MODIFICATION REQUEST:

***Residential Development Stage 1 Phase 1
Royal Rehabilitation Centre, Ryde***

MP10_0189 MOD 4

***Design changes to two dwellings and temporary
use of one dwelling as a Sales and Marketing
Suite.***

Figure 4: Front elevation as proposed (source: Proponent's Application)

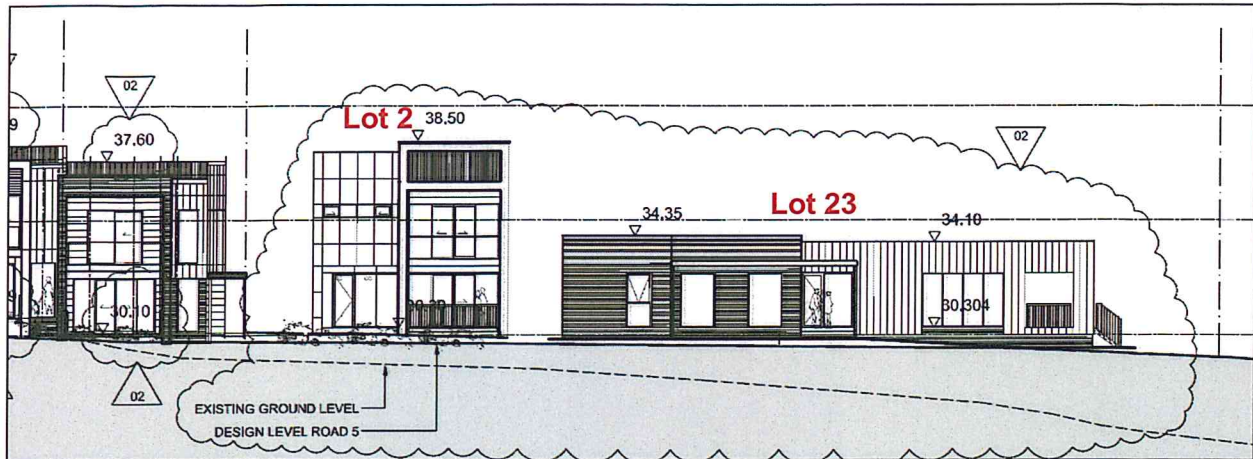
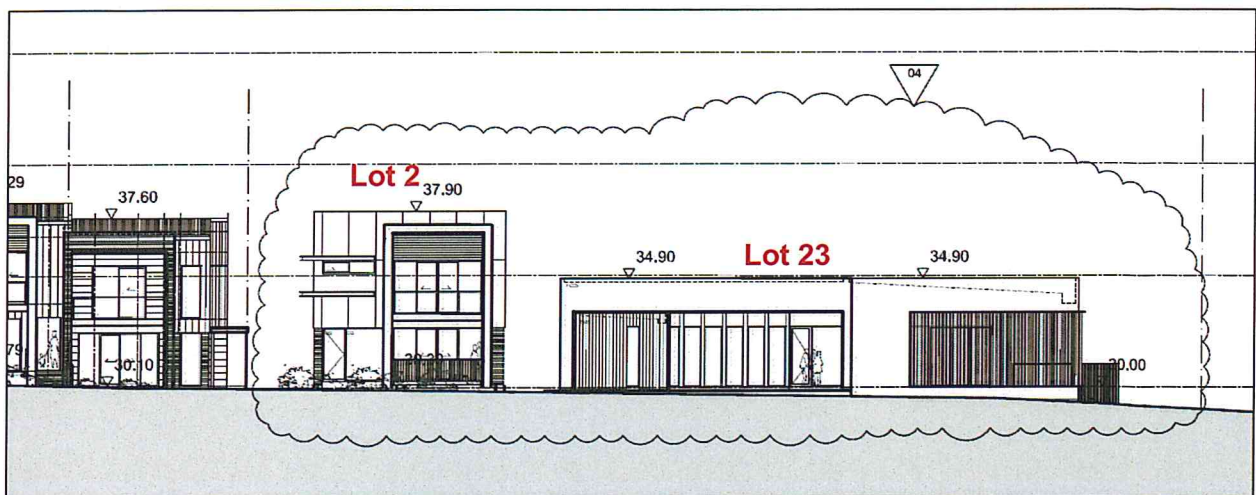
- (b) minor changes to the design of the building on Lot 23 (known as Housing Type 2E) including amendments to the roofline and increase of maximum building height by 0.8m, internal reconfiguration of room layouts, amendment of window locations and sizes, and amendments to external building materials; and

The minor increase in building height to Lot 23 results in a building which remains below the height limit of 9.5m for this section of the site and is acceptable in the context of adjoining developments. Proposed internal changes are considered to improve the functionality and amenity of the two dwellings.

Figure 5: Site layout and parking associated with the sales suite (source: Proponents Application)

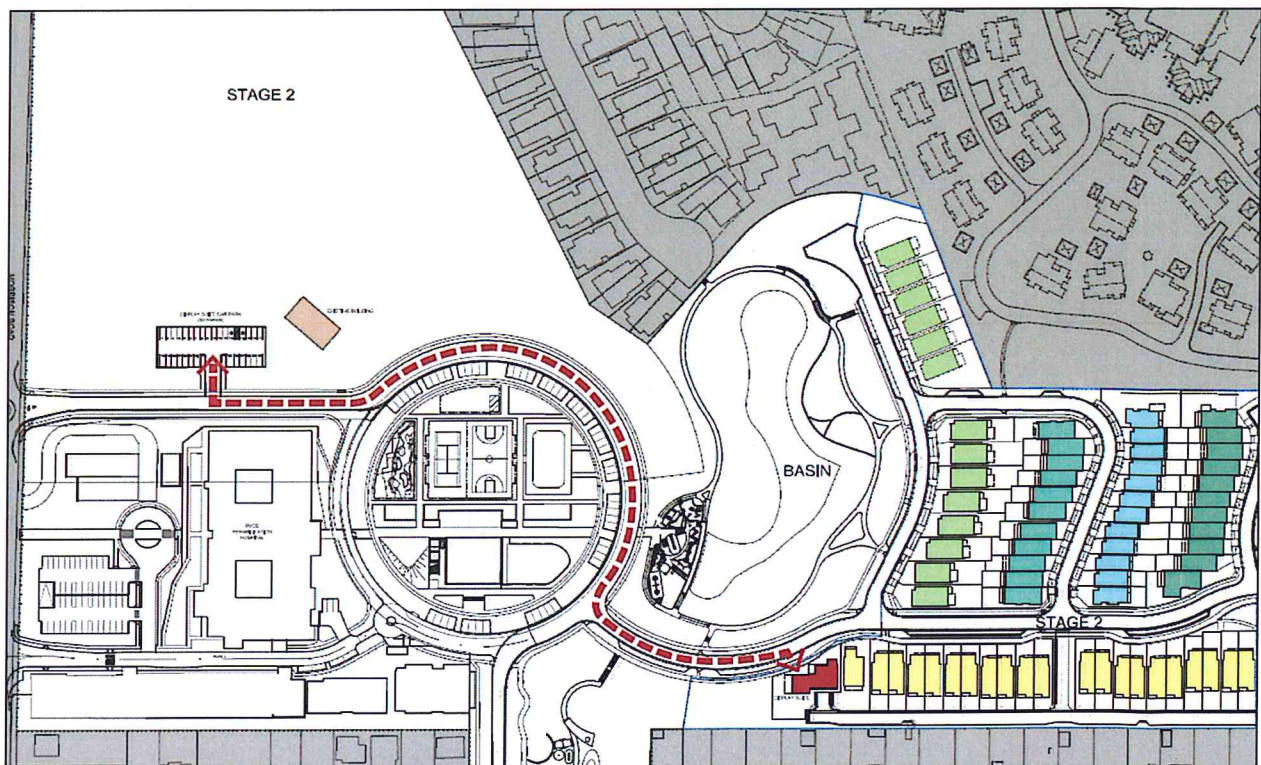
Ryde Development Control Plan 2014 requires parking for offices at the rate of one space per 40m² of GFA. Application of these rates results in a requirement for five spaces for the sales and marketing use. In addition to the two parking spaces within the building that could be used by staff, an existing carpark with 30 parking spaces located within the Stage 2 site (shown in **Figure 5**) will be made available and signposted to encourage customer parking in this location, away from the Stage 1 residential area. In addition, there are 11 on street parking spaces located immediately adjacent to the proposed sales suite on Road 5, also located away from the residential properties in Stage 1. The Department therefore concludes that there is sufficient customer parking available to support the proposed temporary use, without unacceptable impacts to the adjoining residential area.

Parking for the sales and marketing suite must be provided in accordance with Plan No A-PA-DS-FP-00 in Condition A2 and must be appropriately signposted throughout the site.
